Re: **Submission of PG&E's 2026-2028 Wildfire Mitigation Plan Revision Notice Response Non-Substantive Errata**

Errata to Pacific Gas and Electric Company's 2026-2028 Wildfire Mitigation Plan Revision Notice Response

Figure PG&E-8.3.8.2-1: Inspection Selection Process
(in the 2026-2028 Base WMP)

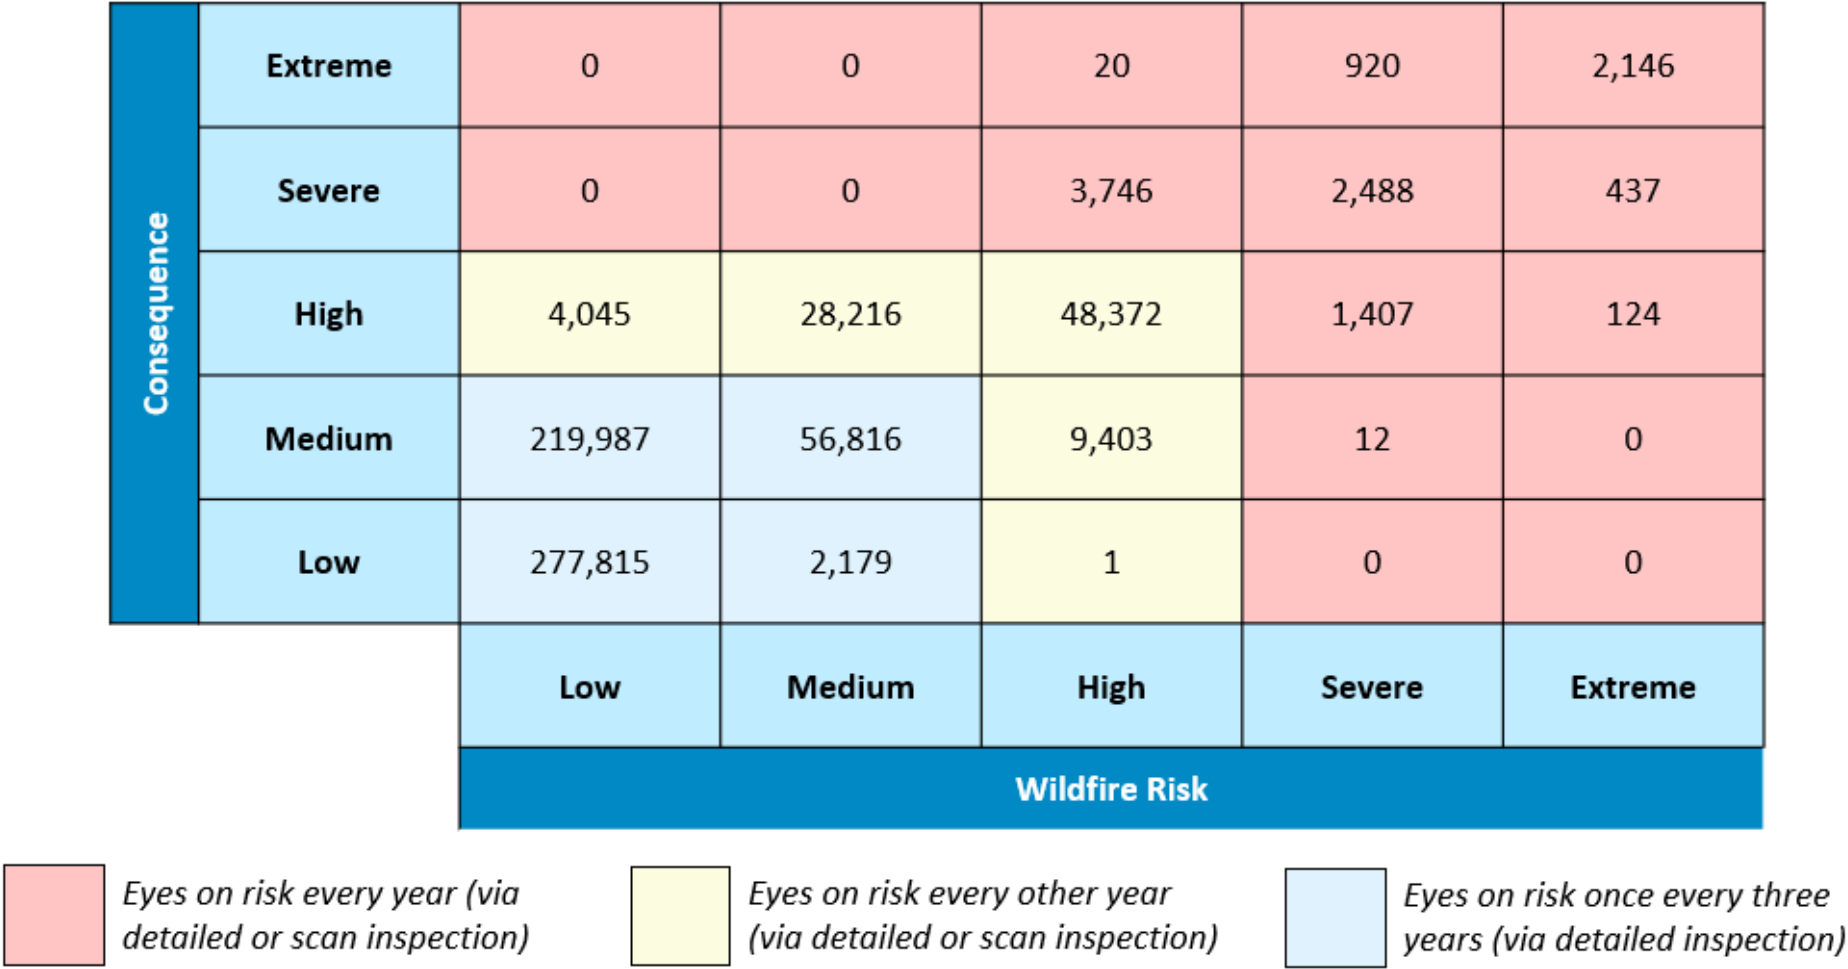
Issue/Reason for Correction	Location of Issue in the	Adjustment(s) Made
11	Table update to correct typographical error for GH-14	2026-2028 Base WMP R1 Vol.1: Table 8-1: Grid Design, Operation, And Maintenance Targets By Year, P. 179	Replaced Table 8-1 with updated % Planned in HFTD for 2026 for GH-14. n/a 100% 100% See Attachment 5 below
12	Table update to remove unnecessary line item	2026-2028 Base WMP R1 Vol 1: Table PG&E-8.2.1-4: Covered Conductor And Undergrounding Impacts On The Likelihood Of Ignition, P. 198	Replaced Table PG&E-8.2.1-4 with removal of Risk Driver: Wire-to-wire Contact. See Attachment 6 below
13	Table update to remove unnecessary line item	2026-2028 Base WMP R1 Vol.1: Table PG&E 8.3-1: Asset Inspection Frequency, Method, And Criteria, P. 231	Replaced Table PG&E 8.3-1 with removal of Inspection Activity: Aerial Pilot. See Attachment 7 below
14	Figure update to use more precise language	2026-2028 Base WMP R1 Vol.1: Figure PG&E-8.3.8.2-1: Inspection Selection Process, P. 244	Replaced Figure PG&E-8.3.8.2-1 with updated language for clarity. See Attachment 8 below
